Product Change Notice (PCN)

件名： RL78/F12, F13, F14 シリーズ、SSOP 製品の Cu ワイヤ化

発行日： 12/25/2024

マーク例

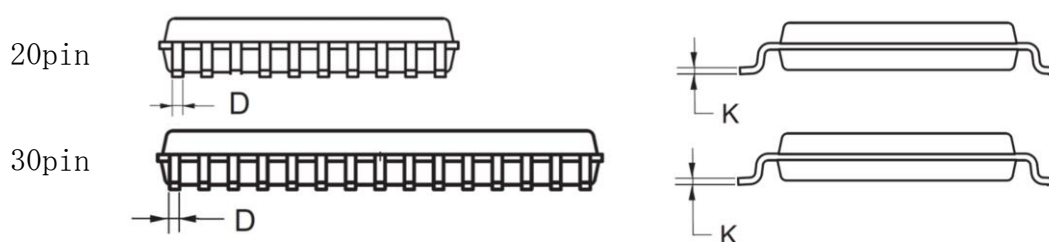
■マーク

製品型名の変更に伴い、以下の通り、一段目の製品型名部分が変更になります。
